UNC Charlotte Phase 16

Addendum #4

Revision Narrative

2021-09-08

E-203S

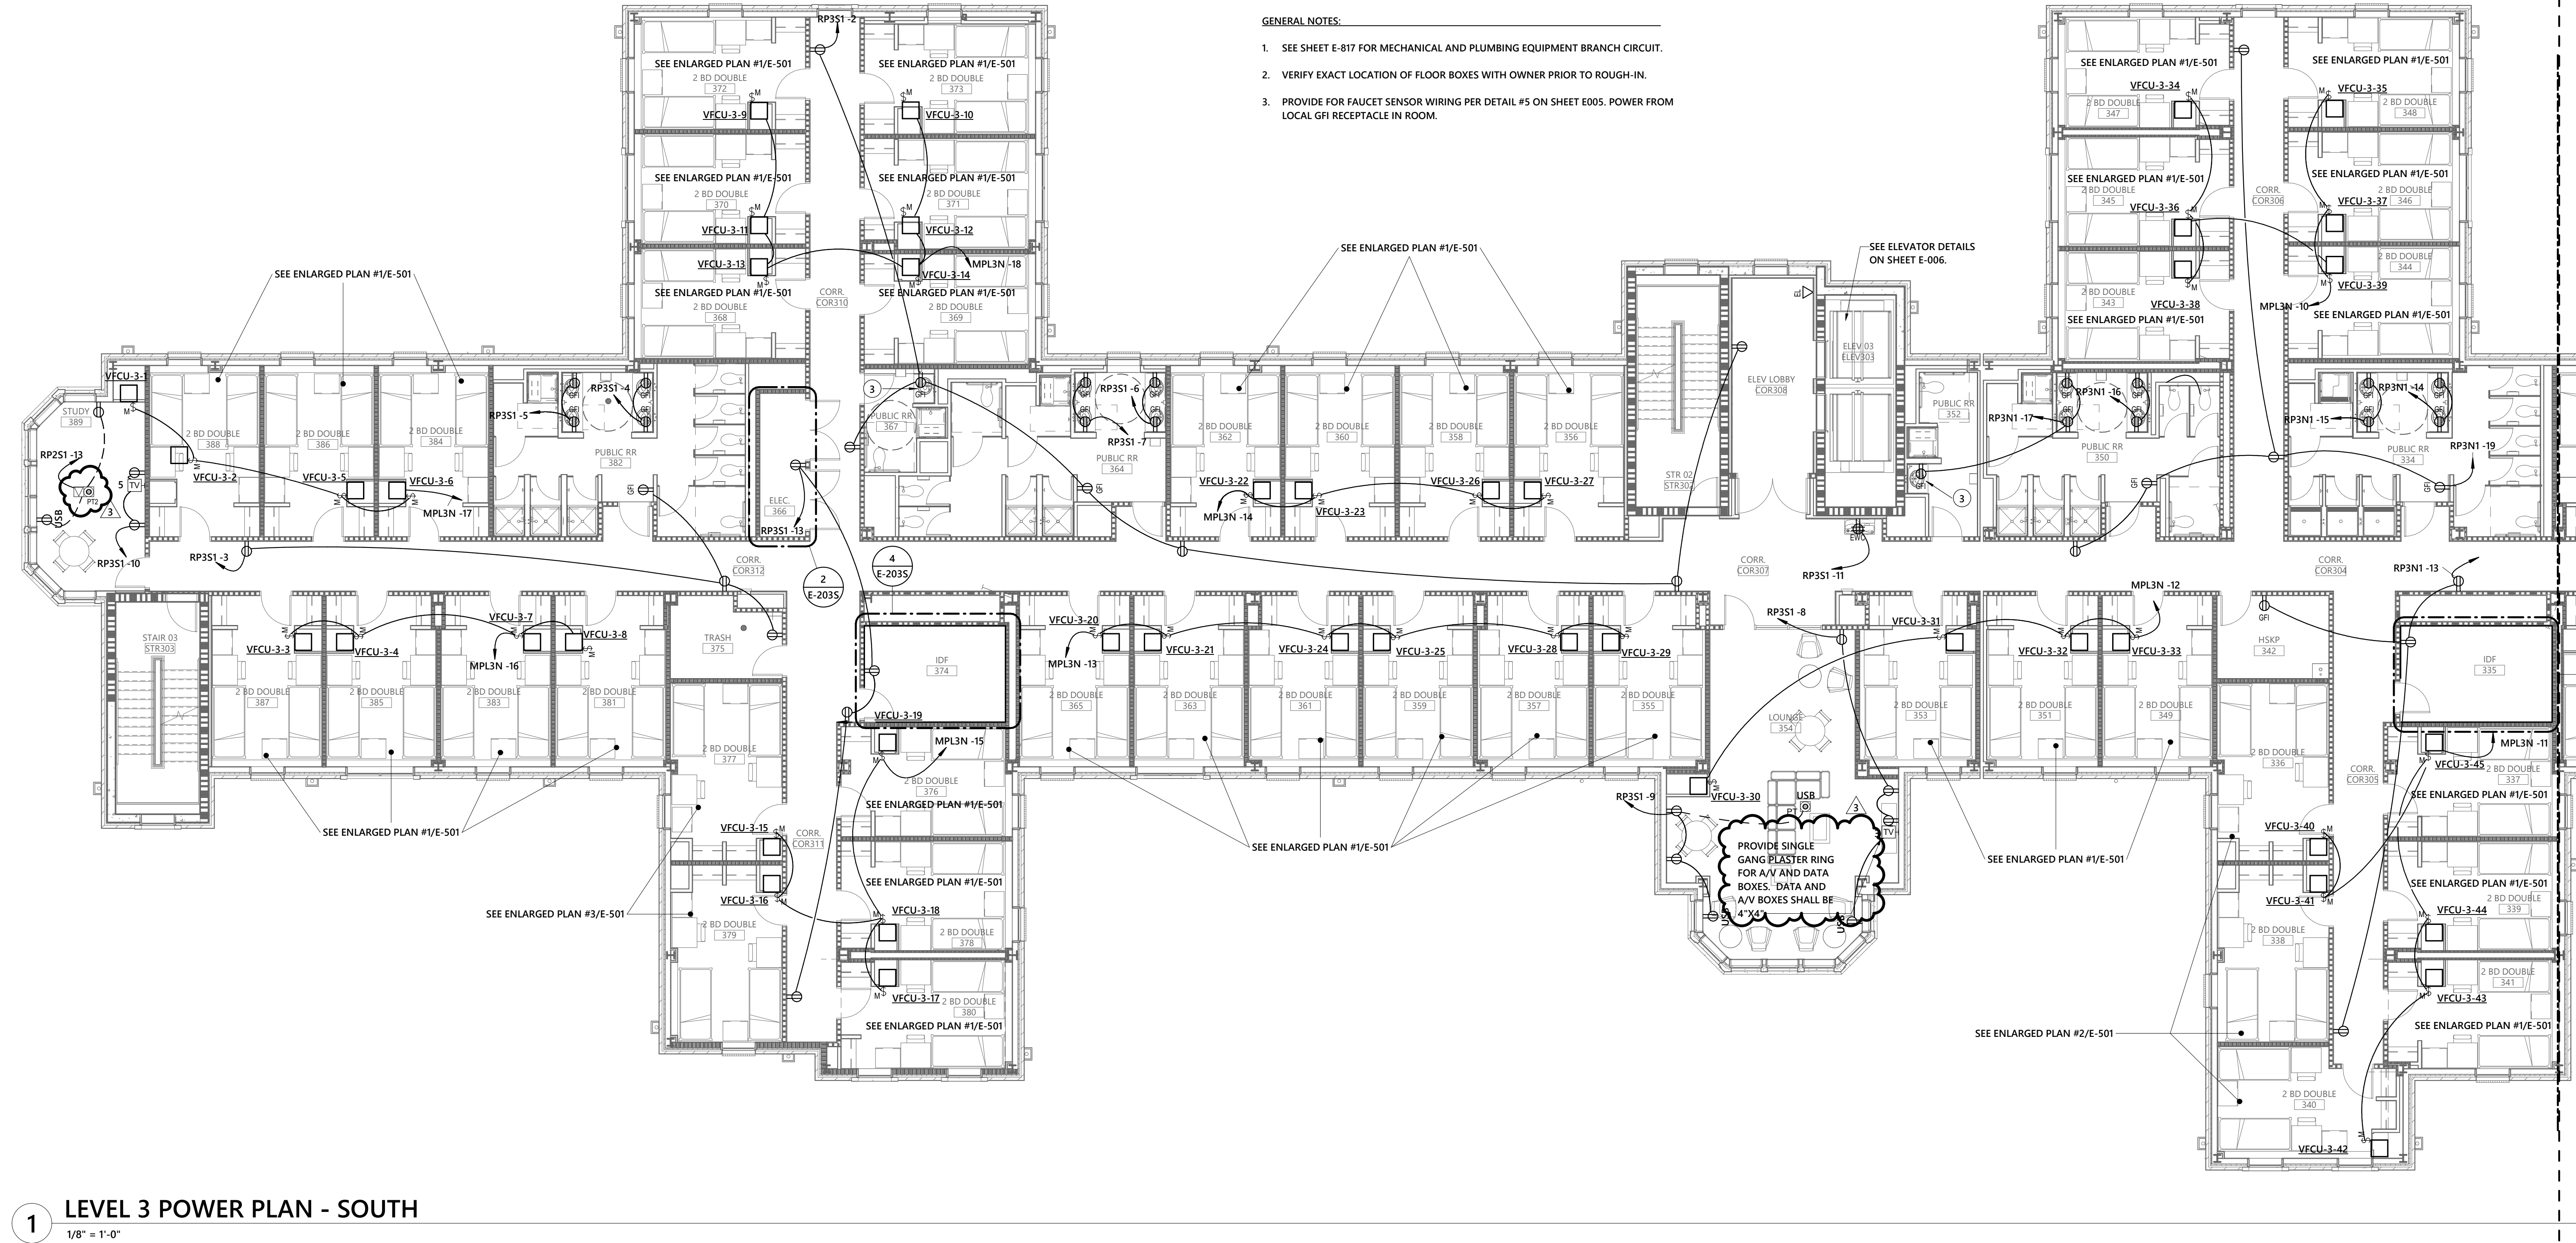
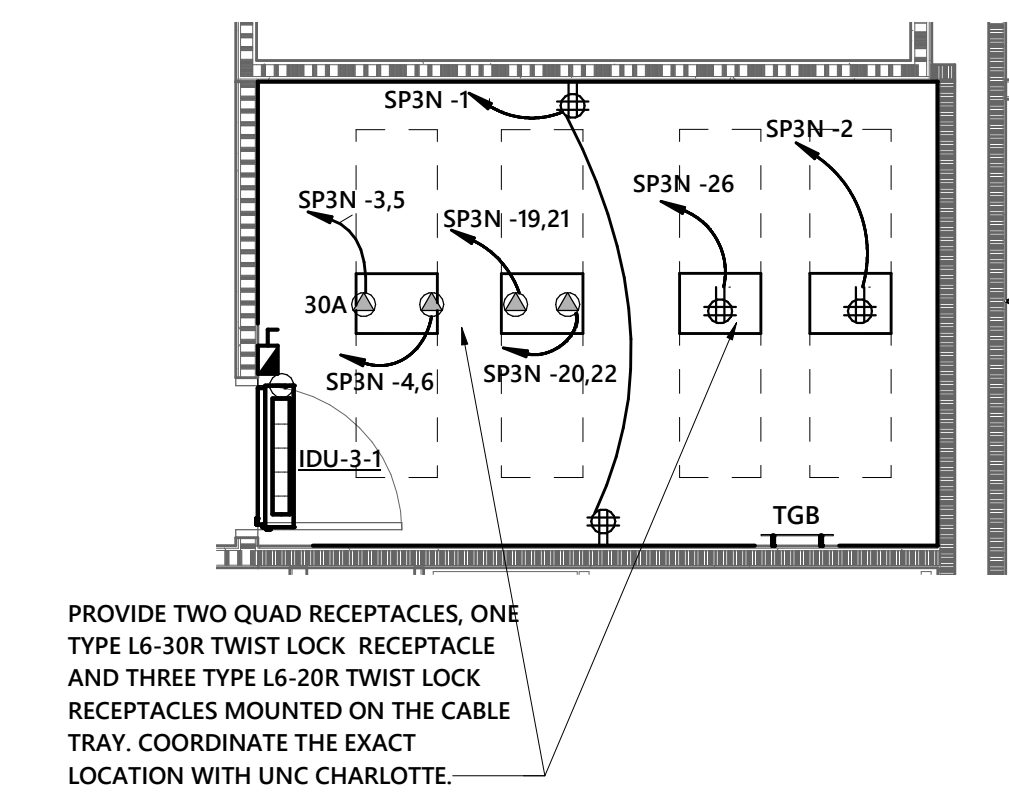
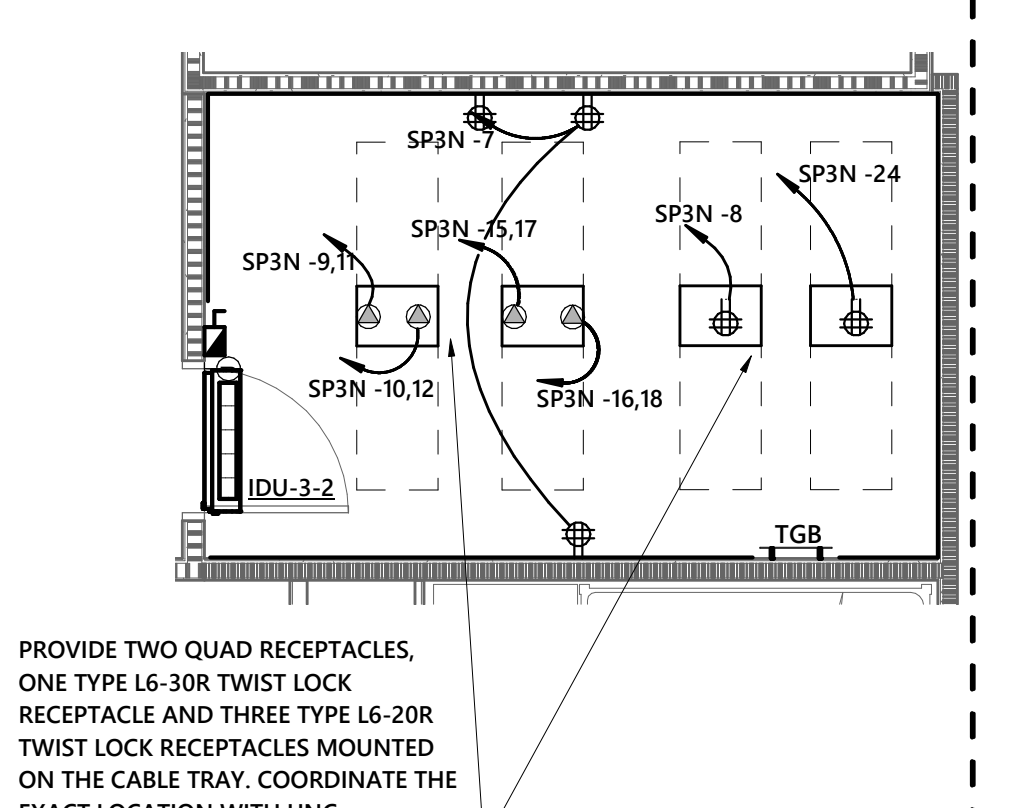
E-203S - Changed TV type. Added note for opening type of junction box. Poke thru type changed.

E-204N

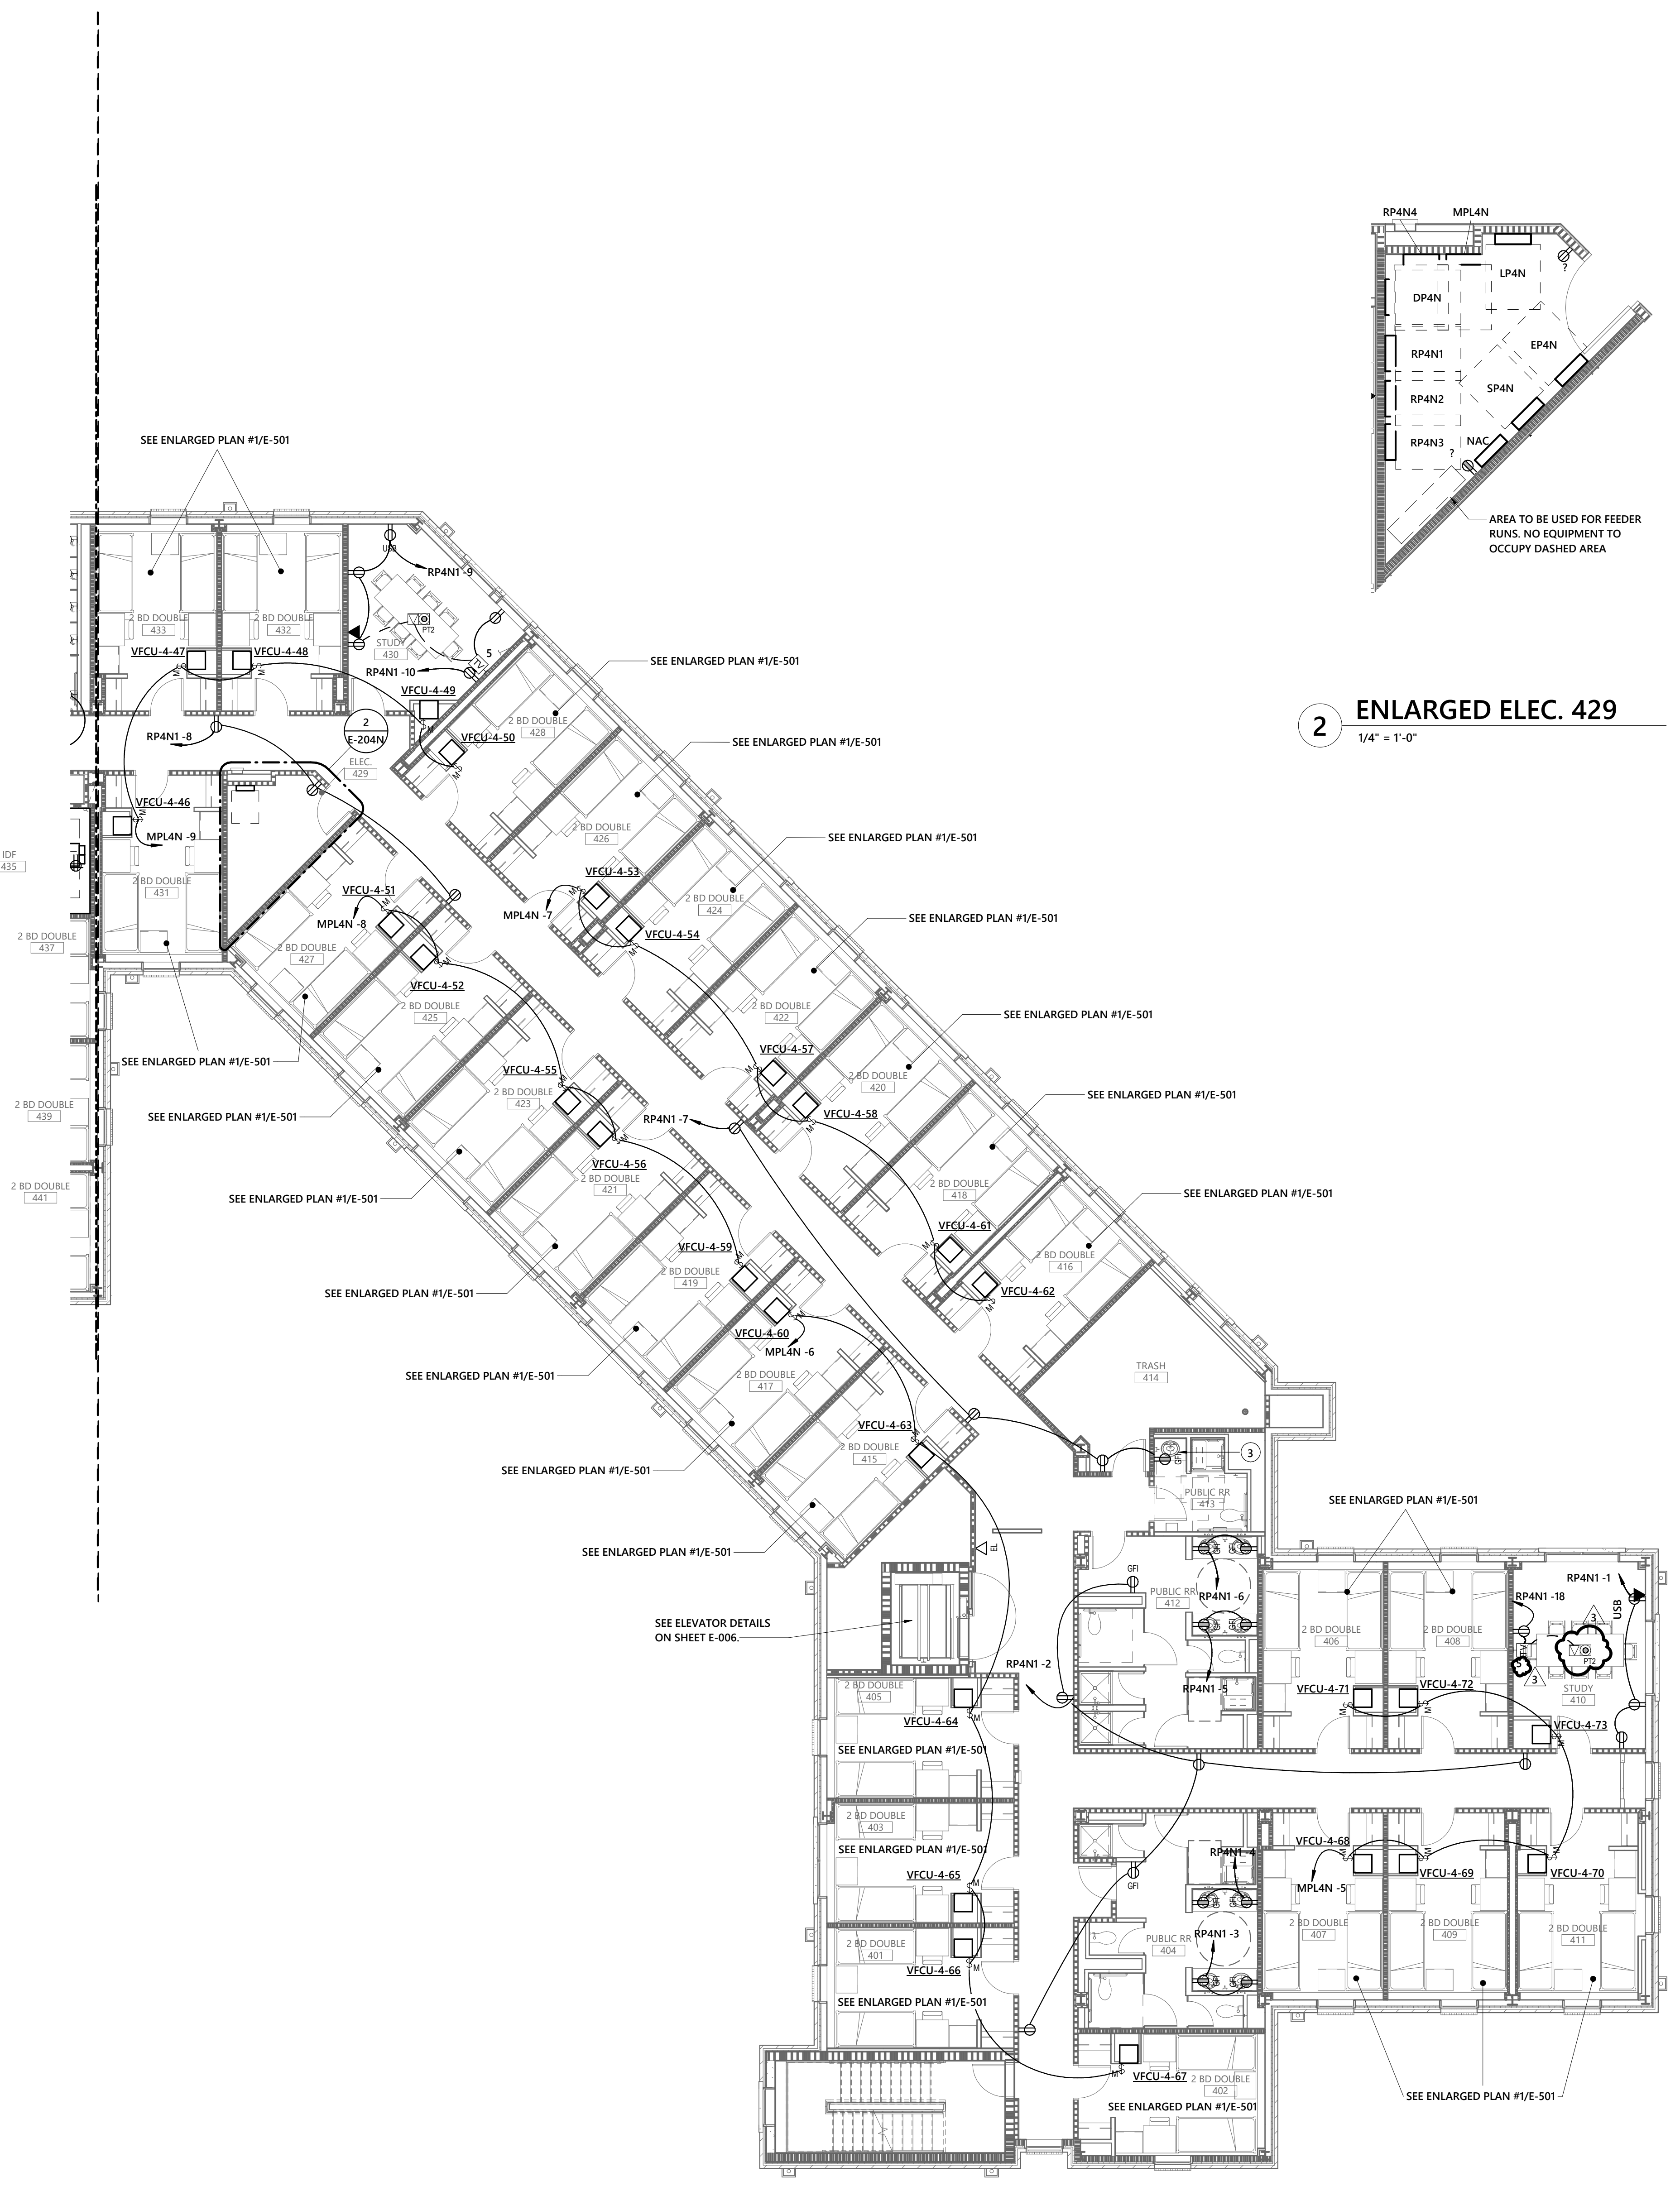
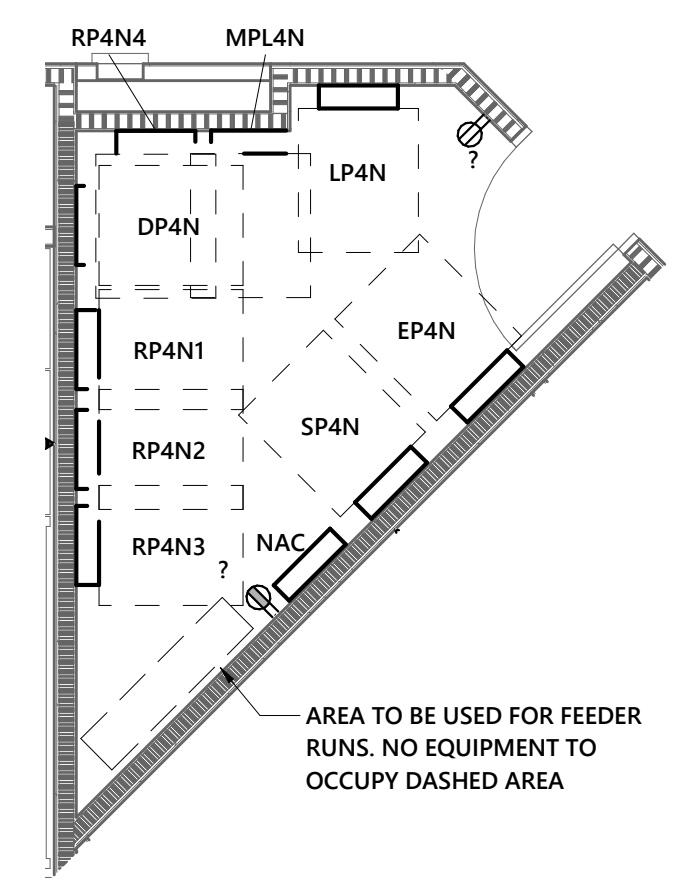
E-204N - Changed TV type. Poke thru type changed.
